ISSUE: Permit to Demolish/Capsulate (partial) and Certificate of Appropriateness for addition and alterations

APPLICANT: Lawrence Farrell

LOCATION: Old and Historic Alexandria District
801 South Fairfax Street

STAFF RECOMMENDATION

A3.1 - NORTH ELEVATION

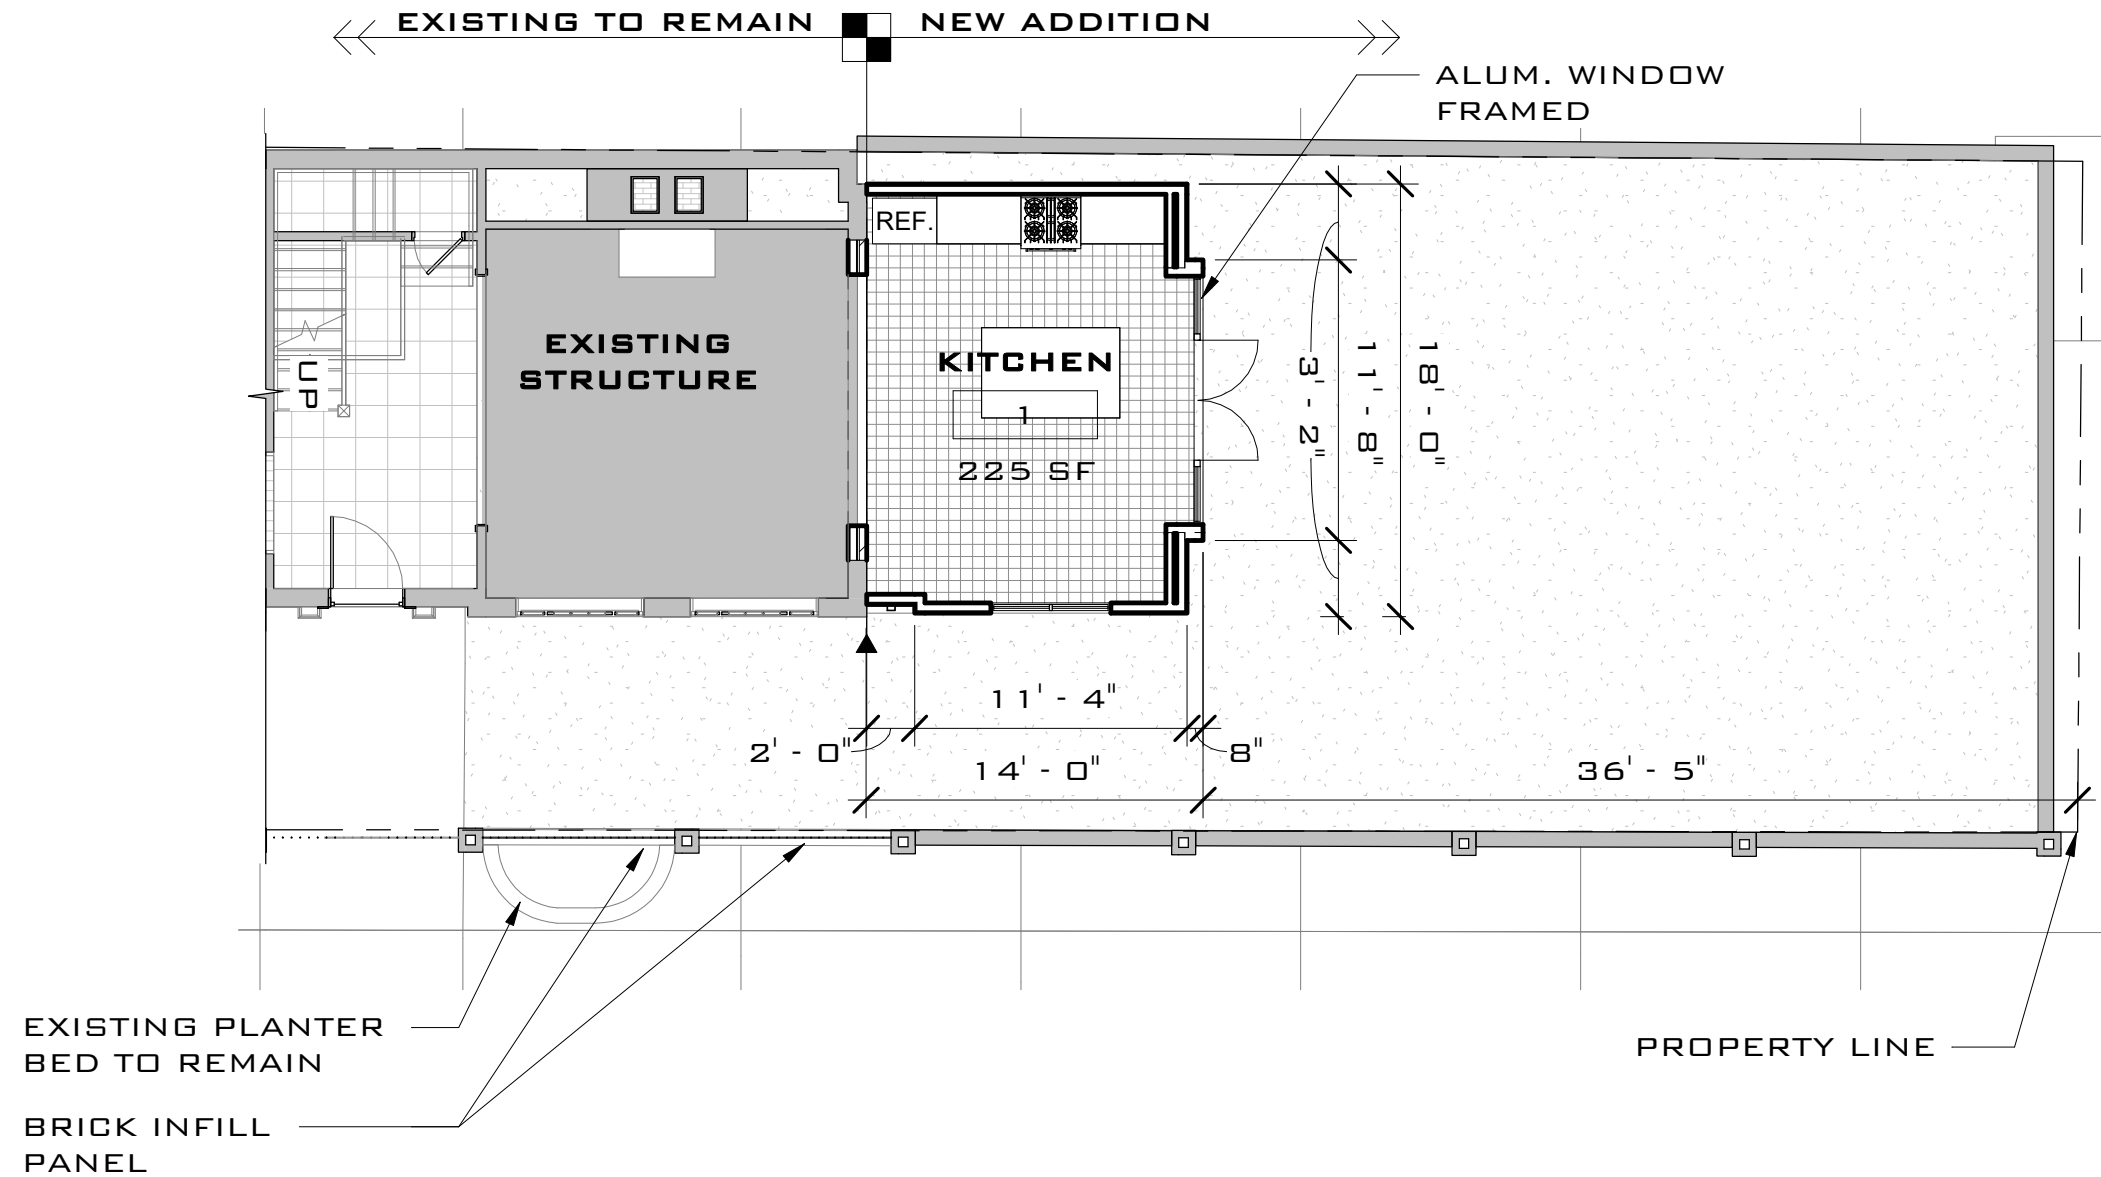
According to the *Design Guidelines*, “The Boards generally prefer addition designs that are respectful of the existing structure and which seek to be background statements...” The one-story addition fulfills these parameters, as it is clearly subservient to the rest of the house. The design artfully tucks this addition under the existing second-story bay window (see Figure 1) and the use of brick veneer cladding relates the addition to the existing structure. Although staff does not normally approve of painting masonry, in this case the applicant’s proposal to whitewash or paint the veneer will further blend the old with the new. The brick wall along the property wall screens the addition from the public rights-of-way, while changing the two wrought-iron sections to brick will further obscure the addition.

Figure 1: North elevation: Addition to be placed beneath bay window on right. The brick garden wall below the two wrought-iron panels in foreground will be elevated slightly (see application sheet A3.1).
